# Access Compliance Report

### (Curb Ramps)

Intersection ID: 44757	Main Street: BONNER_BRIDGE_CT	Cross Street: KINGS_PARADE_BV	Location: SE
ADA ID: 458BFEA8E6BC	Ramp Type: PerpDiag	Initial Pass/Fail: Fail	Overall Compliance: No
Severity Score: 8.75			
Codes/Mitigation Info/Possible Solution		Field Measurements/Component Compliance

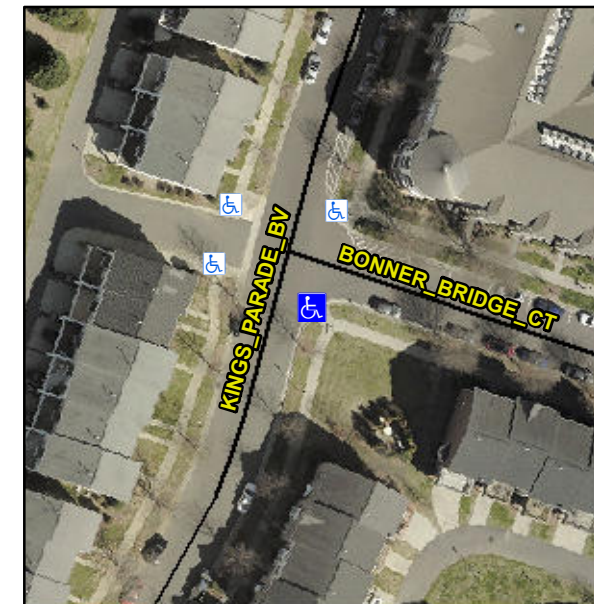
**Not Found, R304.5.1**

Compliance	Description	Data	Compliance	Description	Data
N/A	Ramp Length (in)	97.0	Yes	Ramp Slope (%)	5.2
No	Ramp Width (in)	46.5	Yes	Ramp XSlope (%)	0.4
N/A	Flare Type LT	N/A	N/A	Flare Type RT	N/A
N/A	Flare Slope LT (%)	N/A	N/A	Flare Slope RT (%)	N/A
N/A	Flare Traversable LT?	N/A	N/A	Flare Traversable RT?	N/A
N/A	Landing Length (in)	N/A	N/A	DWS Provided?	N/A
N/A	Landing Width (in)	N/A	N/A	DWS Contrast?	N/A
N/A	Landing Slope (%)	N/A	N/A	DWS Length (in)	N/A
N/A	Landing X Slope (%)	N/A	N/A	DWS Full Width?	N/A
N/A	Landing Curb? (Y/N)	N/A	N/A	DWS Offset (in)	N/A
N/A	Shared Landing?	N/A			
N/A	Gutter Ponding?	N/A	N/A	Gutter Slope (%)	N/A
N/A	Gutter Lip Ht (in)	N/A	N/A	Gutter X Slope (%)	N/A
N/A	Painted X Walk1?	No	N/A	Painted X Walk2?	No
	X Walk 1 Direction	To NE		X Walk 2 Direction	To NW
N/A	X Walk 1 Width (in)	N/A	N/A	X Walk 2 Width (in)	N/A
	X Walk 1 Slope (%)	0.7		X Walk 2 Slope (%)	1.8
	X Walk 1 X Slope (%)	1.5		X Walk 2 X Slope (%)	0.4

**Remove & Replace Curb Ramp With Two New Directional Ramps or Equivalent.**
